Access Compliance Report Public Rights-of-Way (Curb Ramps)

Main Street: **MERCANTILE_WAY** Cross Street: **SECOND_ST** Location: **W**

ADA ID: **RPRK211027170804** Ramp Type: **Type 4 - Parallel** Initial Pass/Fail: **Fail** Overall Compliance: **No** Severity Score: **16**

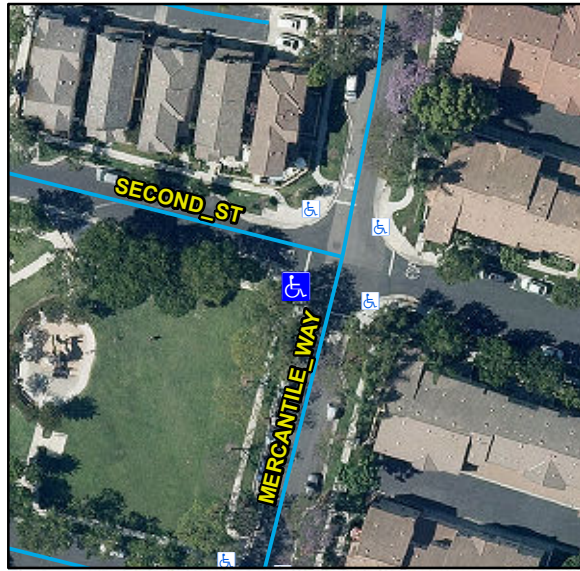
R204.3, R304.5.3, R304.3.2, STD 1115

Compliance	Description	Data	Compliance	Description	Data
N/A	Ramp Length LT (in)	110	N/A	Ramp Length RT (in)	110
Yes	Ramp Width LT (in)	90	Yes	Ramp Width RT (in)	90
Yes	Ramp Run Slope LT (%)	3.6	No	Ramp Run Slope RT (%)	9.3
No	Ramp Cross Slope LT (%)	2.4	Yes	Ramp Cross Slope RT (%)	1
N/A	Landing Present	N/A	N/A	DWS Provided	N/A
N/A	Landing Length (in)	N/A	N/A	DWS Contrast	N/A
N/A	Landing Width (in)	N/A	N/A	DWS Length (in)	N/A
N/A	Landing Run Slope (%)	N/A	N/A	DWS Full Width	N/A
N/A	Landing Cross Slope (%)	N/A		DWS Offset Type	N/A
N/A	Landing Movement Obstructed?	N/A	N/A	DWS Offset Left (in)	N/A
	Landing Movement Type	N/A	N/A	DWS Offset Right (in)	N/A
N/A	Landing Shared	N/A			
N/A	Clear Space	Yes			
N/A	Clear Space To Crosswalk (in)	N/A			
N/A	Marked Crosswalk 1	No	N/A	Marked Crosswalk 2	No
	Crossing 1 Direction	SE		Crossing 2 Direction	NE
	Marked Crosswalk 1 Width (in)	N/A		Marked Crosswalk 2 Width (in)	N/A

Remove & Replace Curb Ramp With Two New Directional Ramps or Equivalent.
